SERVICE BULLETINS

SUBJECT: Improved modulation

SUBJECT: Noise Blanker on Cobra 29

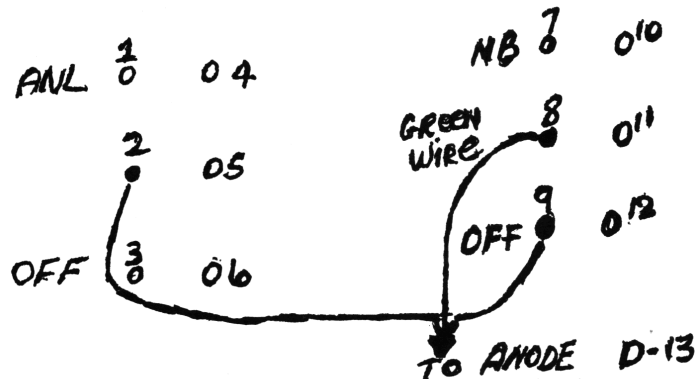
PROBLEM: To improve the modulation sensitivity and spectrum of the Cobra 29, the following changes should be made.

1. Change R98 to 2.7K
2. Change R99 to 3.3K
3. Change R60 to 470 ohms
4. Delete C97
5. Change C135 to 0.0047mfd
6. Change C57 to 0.0022mfd
7. Reverse L8
8. Install a heat sink on driver transistor TR19

NOTE: Above components were not used on all Cobra 29 production.
